EPR2 | ELECTRIC POWER
RESEARCH INSTITUTE

MRP-169 NRC RAI Response NRC Meeting

August 23, 2007

MRP-169 RAIs – Significant Questions and Responses

PWOL Mockup Stresses vs. Surge Nozzle WOL Calculations

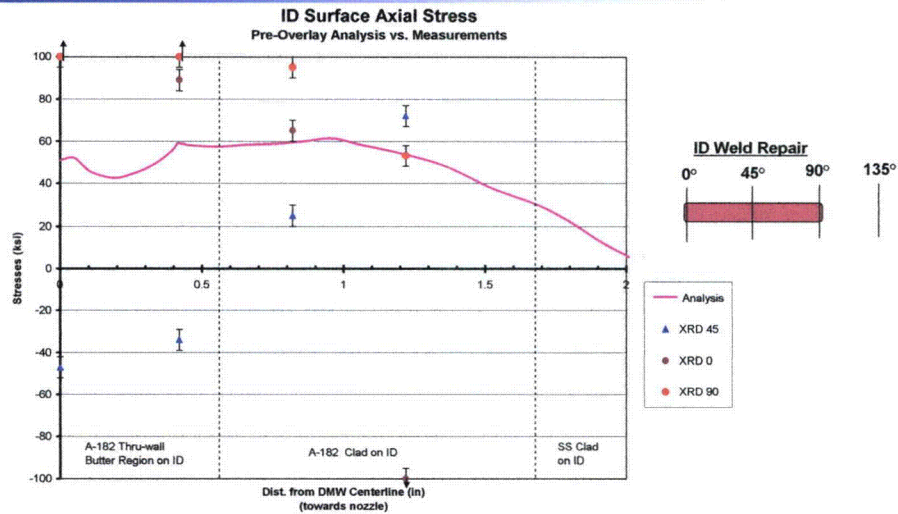
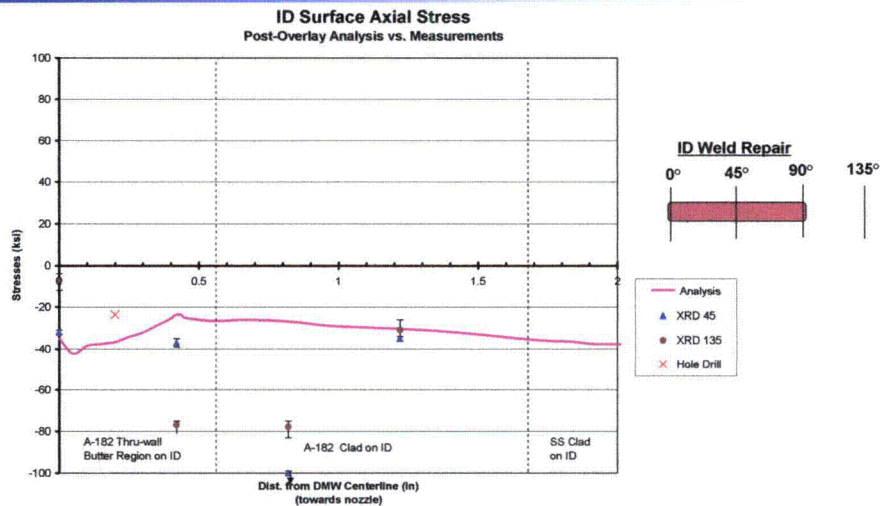
- Stress Analysis #4 – Discuss why stress distributions in mock-up PWOL are different from those in example nozzle PWOLs
- Response –
 - PWOL mockup simulates a surge nozzle. Surge nozzle stress contour plots will be added to revised MRP-169
 - Mockup residual stresses in Section 5 were reported at room temperature for comparison to XRD measurements, surge nozzle example in Section 8 was reported at operating temperature
 - Post-overlay residual stresses for mockup and surge nozzle example do not differ significantly under consistent conditions
 - Detailed stress plots are provided in RAI response that demonstrate this point

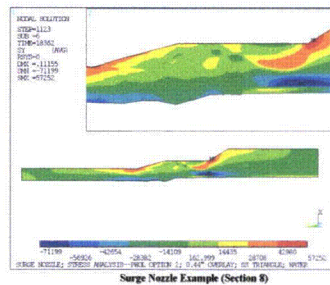
- LBB #2 – Please clarify that LBB analyses need to be performed for PWOLs applied to welds in piping systems that were approved for LBB.
- Response – Review existing LBB calculations for flaw tolerance and assess plant risk using existing PRA event trees.
